Access Compliance Report

Public Rights-of-Way

Intersection ID: 26839	Main Street: OLD_COURSE_DR	Cross Street: PREMIER_DR	Location: SE
ADA ID: 3BE7EF320AFA	Ramp Type: PerpDiag	Initial Pass/Fail: Pass	Overall Compliance: No
Severity Score: 10.25			
Codes/Mitigation Info/Possible Solution		Field Measurements/Component Compliance

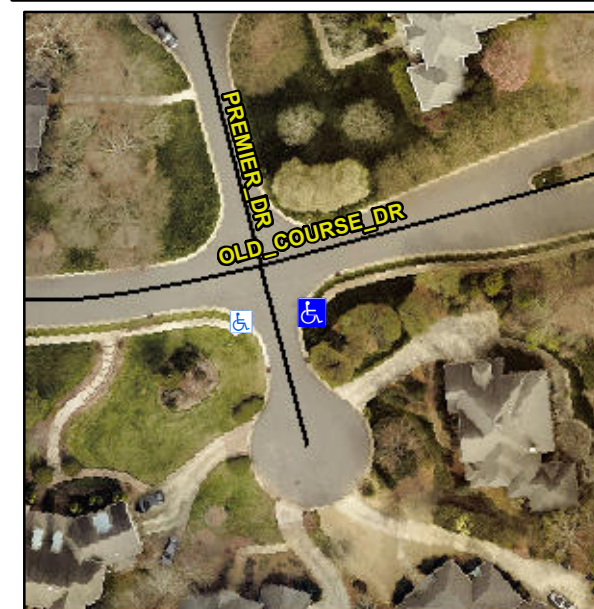
R304.5.3, R304.2.1, R304.2.2-Perp, R304.3.2-Para, R305.2

Compliance	Description	Data	Compliance	Description	Data
N/A	Ramp Length (in)	92.0	Yes	Ramp Slope (%)	6.4
Yes	Ramp Width (in)	48.0	No	Ramp XSlope (%)	4.8
N/A	Flare Type LT	Sloped	N/A	Flare Type RT	N/A
N/A	Flare Slope LT (%)	1.4	Yes	Flare Slope RT (%)	7.6
N/A	Flare Traversable LT?	Yes	N/A	Flare Traversable RT?	Yes
No	Landing Length (in)	N/A	Yes	DWS Provided?	Yes
No	Landing Width (in)	N/A	Yes	DWS Contrast?	Yes
No	Landing Slope (%)	N/A	Yes	DWS Length (in)	24.0
No	Landing X Slope (%)	N/A	Yes	DWS Full Width?	Yes
N/A	Landing Curb? (Y/N)	No	No	DWS Offset (in)	5.0
N/A	Shared Landing?	N/A			
Yes	Gutter Ponding?	No	Yes	Gutter Slope (%)	4.1
Yes	Gutter Lip Ht (in)	0.0	No	Gutter X Slope (%)	2.7
N/A	Painted X Walk1?	No	N/A	Painted X Walk2?	No
	X Walk 1 Direction	To N		X Walk 2 Direction	To W
N/A	X Walk 1 Width (in)	N/A	N/A	X Walk 2 Width (in)	N/A
	X Walk 1 Slope (%)	2.2		X Walk 2 Slope (%)	2.2
	X Walk 1 X Slope (%)	1.7		X Walk 2 X Slope (%)	1.1

Remove & Replace Curb Ramp With Two New Directional Ramps or Equivalent. Remove & Replace Gutter.
